IMPORTANT SAFETY RECALL NOTICE

| Subject Öhlins TTX36 Shock absorbers | Date 03/25/2015 | Page 1(3) |

Öhlins Racing AB has determined that a defect which relates to motor vehicle safety exists in **certain batches and part numbers** of aftermarket TTX36 (TTX GP, TTX RT & TTX36 MKII) MC shock absorbers produced between 11-06-2013 and 02-19-2015.

Component assembly shown in figure below.

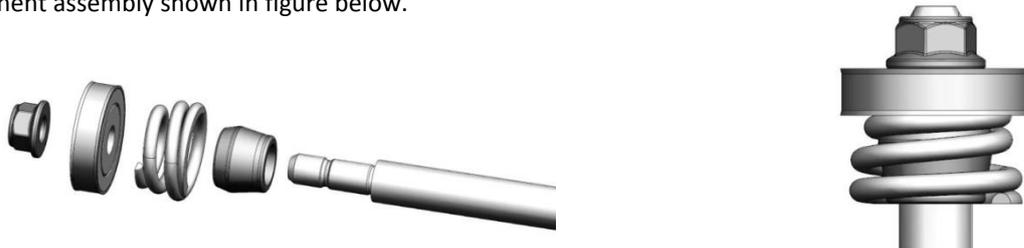
The cause for this defect is the piston-shaft nut which in some cases has not been torqued at full metal to metal contact because the top out spring is preventing the piston to reach its final position due to high friction.

If the piston-shaft nut comes loose the result will be loss of damping and on some applications it can also cause the shock absorber to come apart. Either of these events may surprise the rider in a way that the rider would no longer have full control of the motorcycle, increasing the risk of a crash.

This assembly defect has been rectified and the issue does not exist on shock absorbers with an earlier or a later batch number.
